New Albany Board of Zoning Appeals Meeting Agenda
November 25, 2024 at 6:30 pm

VAR-65-2024 Variance

Variance to codified ordinance 1169 relating to the size and quantity of signage for QTS located at 1235 and 1225 Beech Road SW (094-106404-00.011 and 094-106404-00.010).

SIGNAGE VARIANCE REQUEST

BUILDING MOUNTED SIGNAGE - QUANTITY

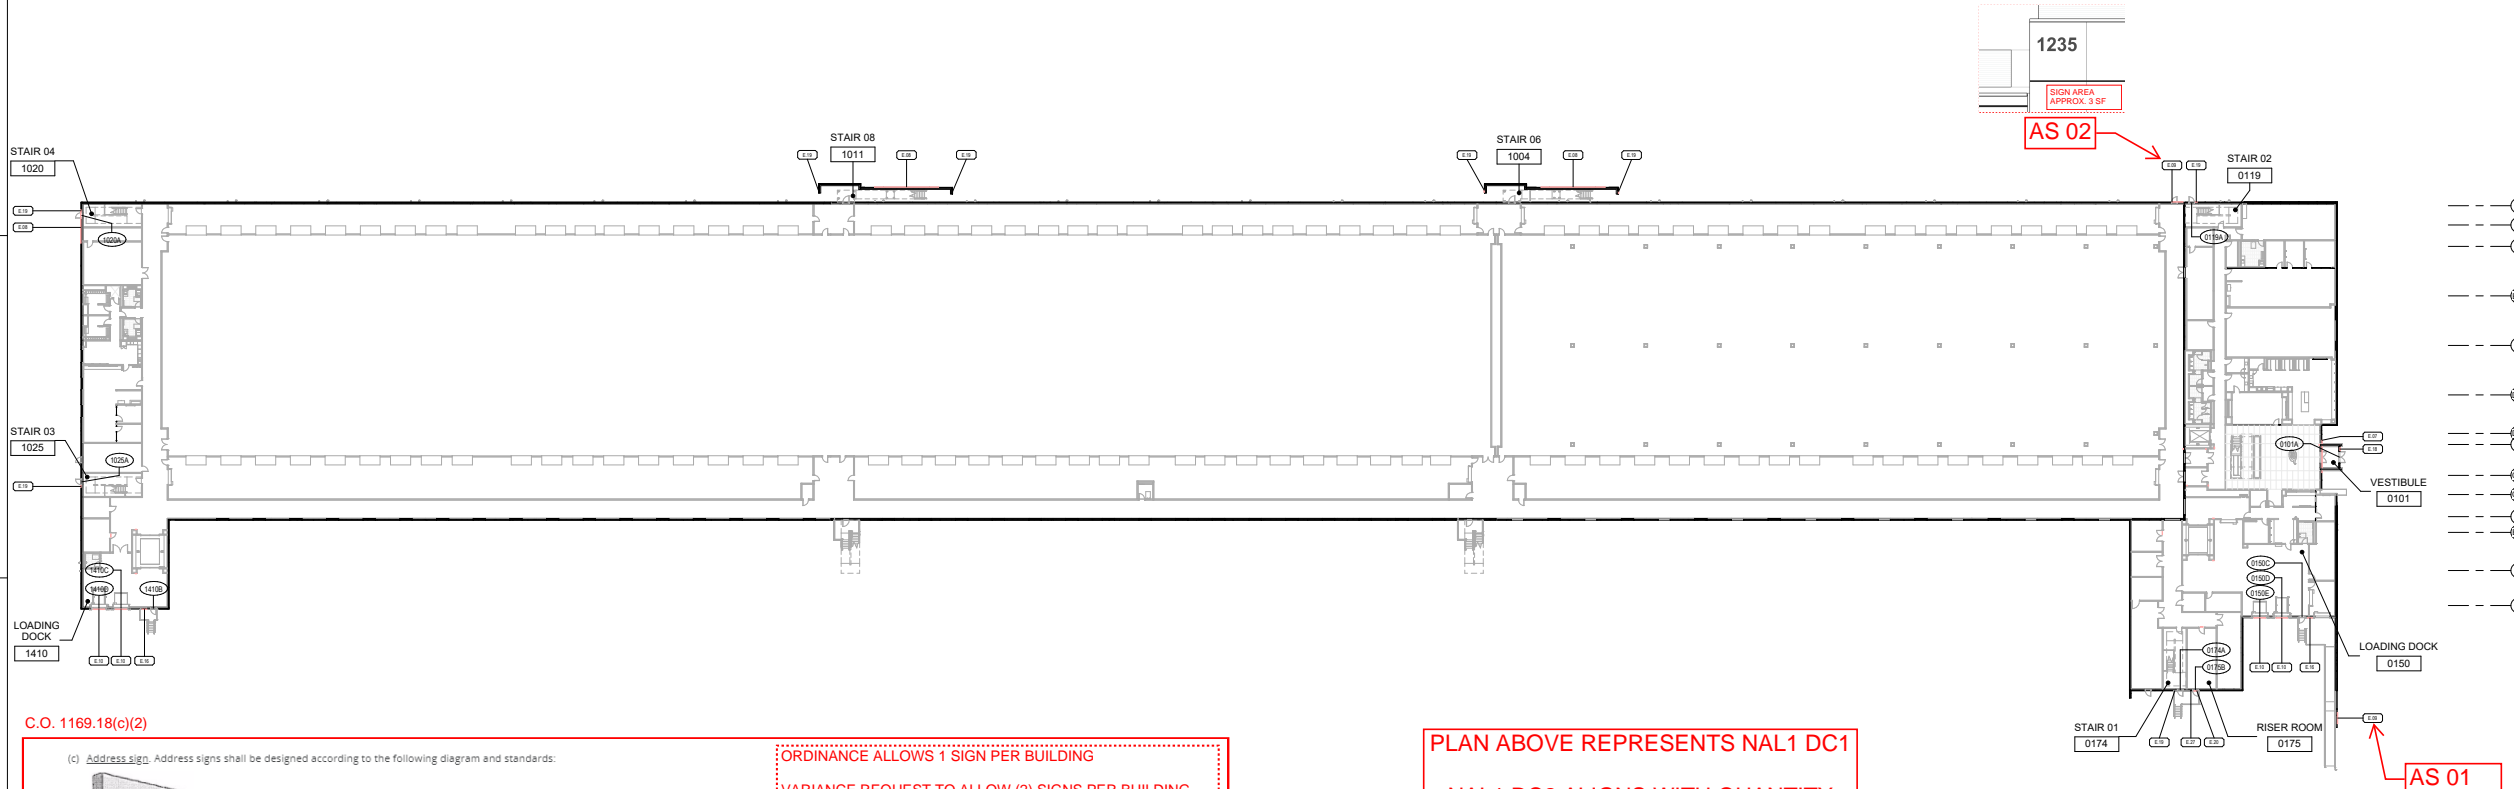
ORDINANCE ALLOWS 1 SIGN PER FRONTAGE.
VARIANCE REQUEST TO ALLOW (4) BUILDING MOUNTED SIGNS PER BUILDING
 MOUNDING LIMITS VISIBILITY TO SIGN ON FRONT ELEVATION, AND SIGNS ON NORTH ELEVATION WOULD BE VISIBLE FROM THE INTERSECTION AT THE NORTHWEST CORNER OF THE SITE. TO ASSIST WITH WAYFINDING AT THE SECONDARY ENTRANCE.
 EACH SIGN ON NORTH ELEVATION HIGHLIGHTS A FACILITIES ENTRANCE FOR EMPLOYEES WARRANTING THE DUPLICATION.
 THE PROPERTY PLAN NORTH EXCEEDS THIS ORDINANCE LIMIT SETTING PRECEDENCE.

2 SIDE VIEW CHANNEL LETTERS - TYPICAL
SCALE: 1" = 1'-0"

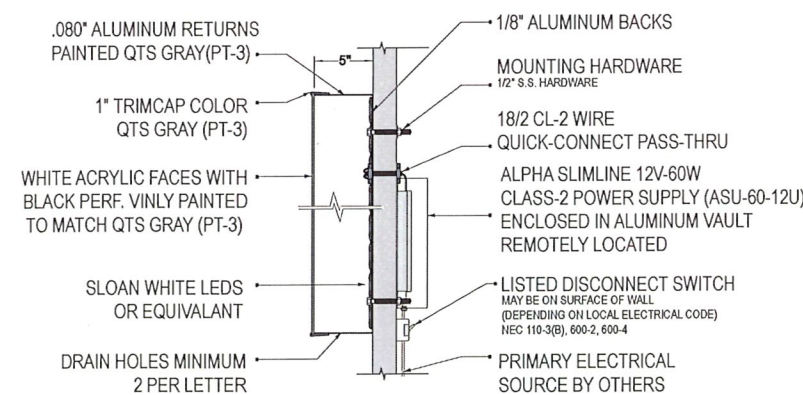
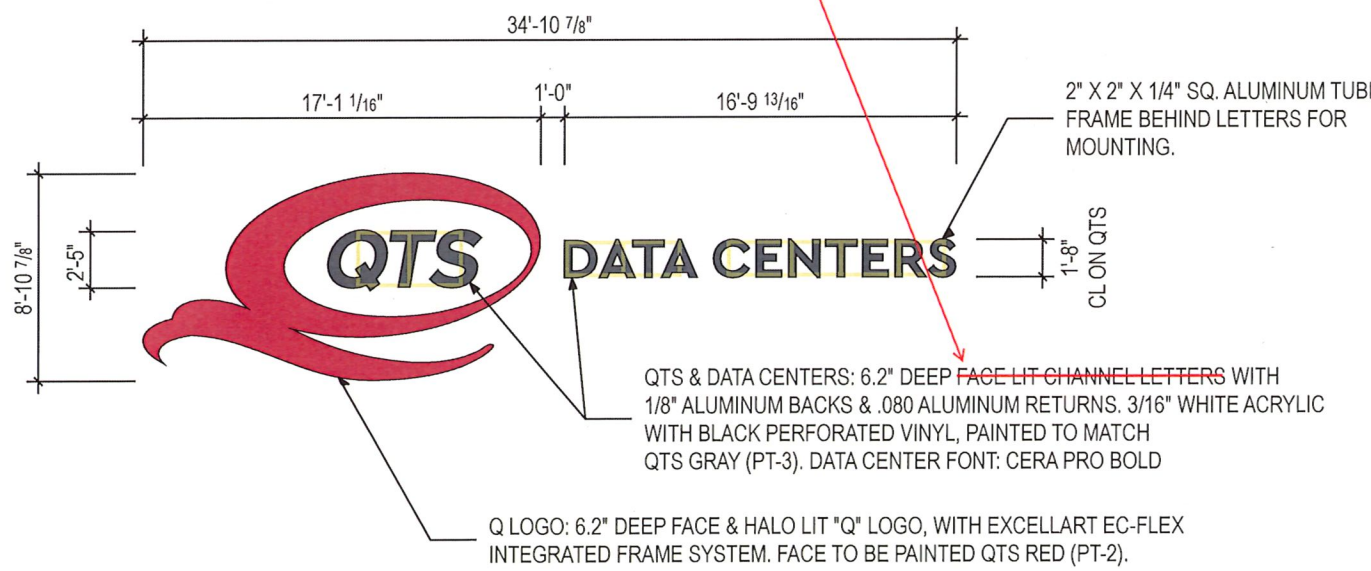
NOTE: PER COORDINATION WITH THE CITY OF NEW ALBANY, HALO BACKLIGHTING TO BE PROVIDED IN LIEU OF FACE LIT CHANNEL LETTERS
